**GOVERNMENT OF THE DISTRICT OF COLUMBIA
DEPARTMENT OF TRANSPORTATION**

MEMORANDUM

SUBJECT: Zoning Commission Case No. 16-06 – Jemal’s Lazriv Water, LLC, 1900 Half Street SW

Figure 1. Site Plan (Source: Applicant)

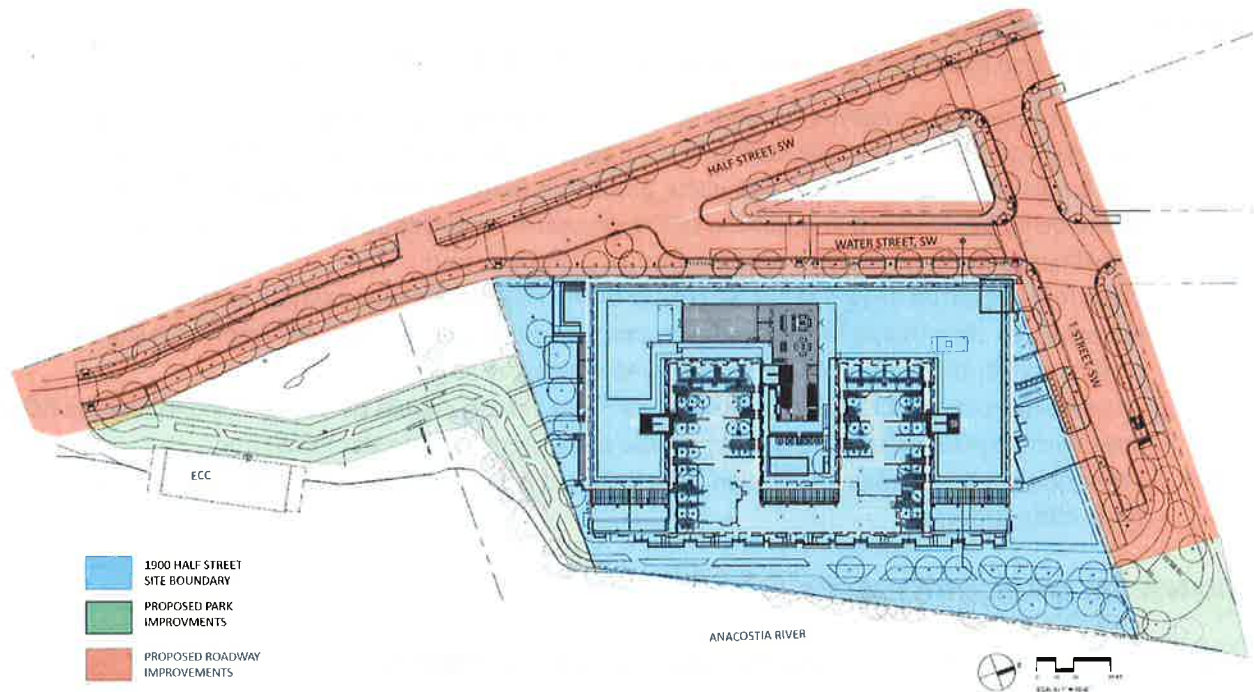
- Provide an updated design at the SE corner of the Half/Water intersection, with the curb extension to slow this right turn and a crosswalk across Half aligned with where the sidewalk coming out from that side of the building intersects the street;

- The reconstruction of Half Street (as well as T and Water) should be straight and follow the ROW lines with an even offset. The streets should be centered within the ROW; and

- Include a cycle track to be separated from the street between the river walk portion and Water Street along T Street;
- Since Water is being converted to one-way to accommodate and improve the Site network, its design should match that operation. The operations will need to be clearly delineated, and pavement marking and/or signing should be provided for both blocks of Water Street. Additionally, the transition to the operations of Water on the block to the north of T must be included (likely a bulbout and striping adjustments) to make the widths match;

- Provide an appropriate design at the SE corner of the Half/Water intersection, with a bulbout to slow this right turn and a crosswalk across Half aligned with where the sidewalk coming out from that side of the building intersects the street; and

- The alignment of Half (and the other streets) should be straight and follow the ROW lines with an even offset. The streets should be centered within the ROW.

Figure 2. Existing Pedestrian Network Conditions (Source: Applicant)

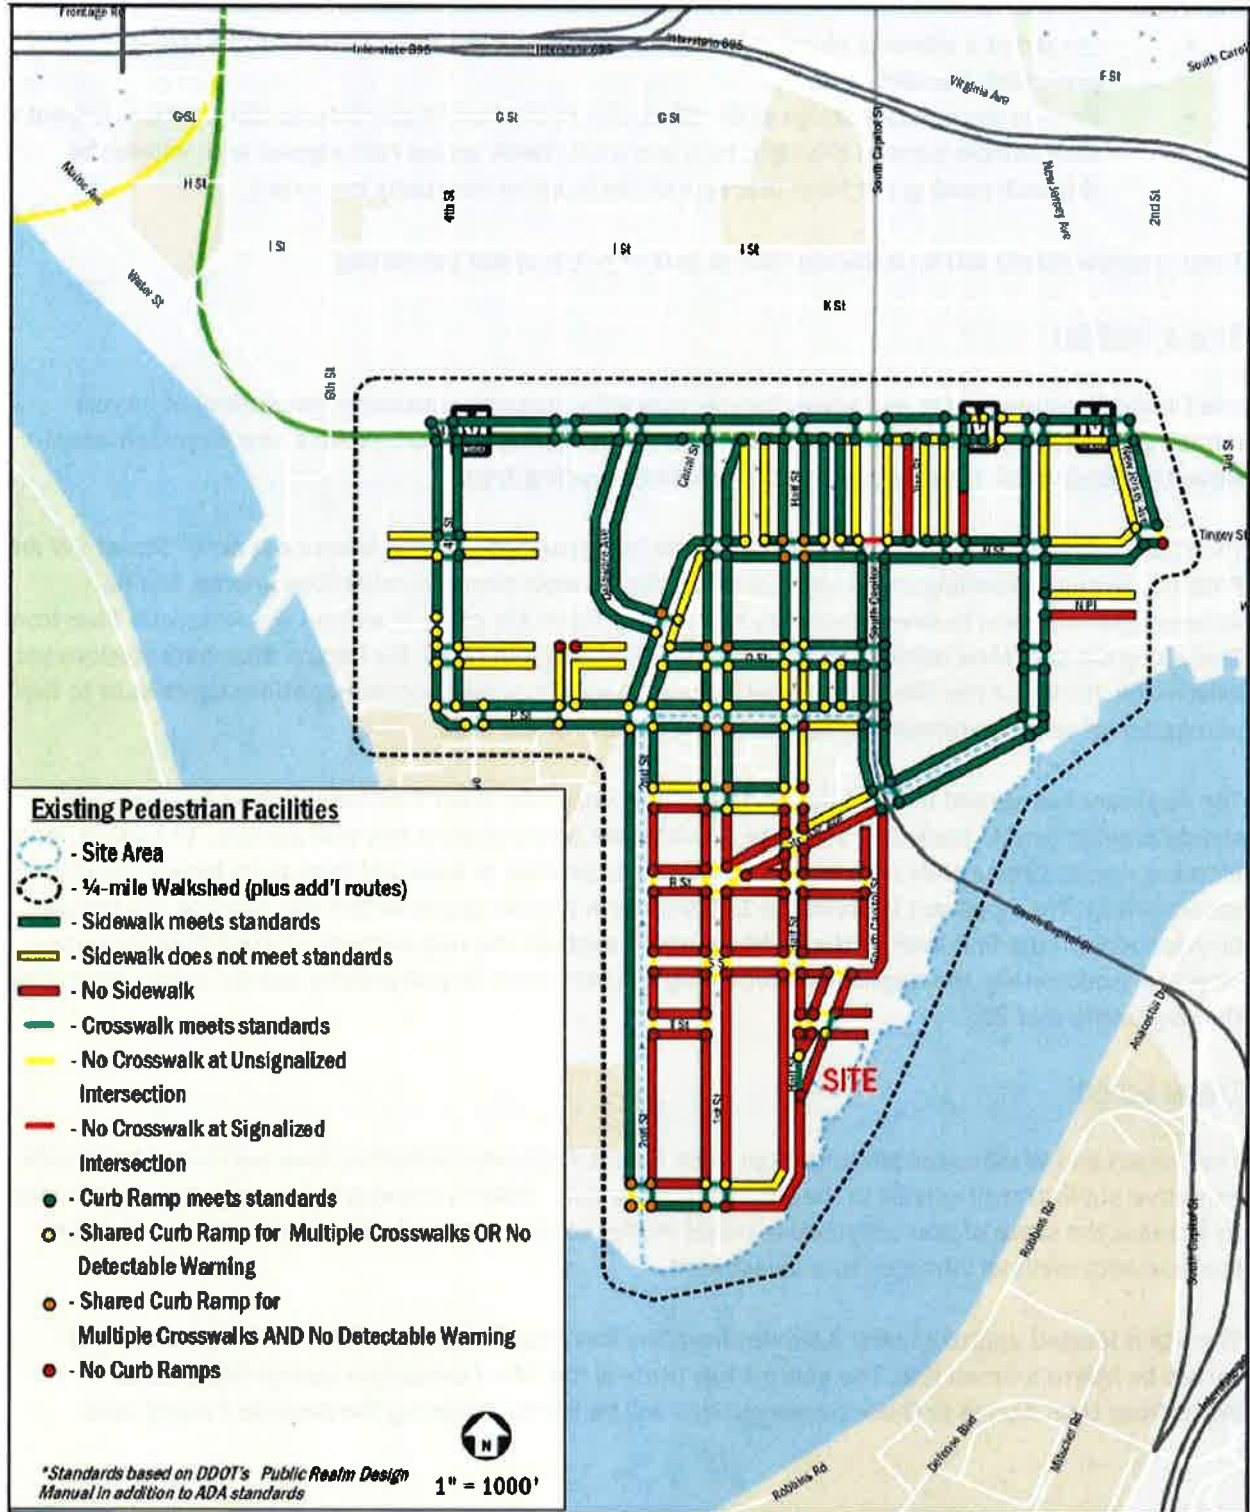
will be via transit, safe passage to the transit locations must be provided. The Applicant's analysis revealed substandard pedestrian facilities in the vicinity of the site, such as missing sidewalks along the route to the Navy Yard Metro station. The condition of the existing pedestrian network is shown in Figure 2.

DDOT seeks standard pedestrian facilities along T Street SW, Water Street SW, and Half Street SW. The Applicant proposes several improvements to bring the existing streetscape up to current DDOT standards. There are a few additional elements DDOT has identified that should be provided. These include:

- Construct a sidewalk along at least one side of Half between T Street and S Street, preferably the east; and
- Provide an updated design at the SE corner of the Half/Water intersection, with a bulbout to slow vehicle turns at this right turn and a crosswalk across Half aligned with where the sidewalk coming out from that side of the building intersects the street.
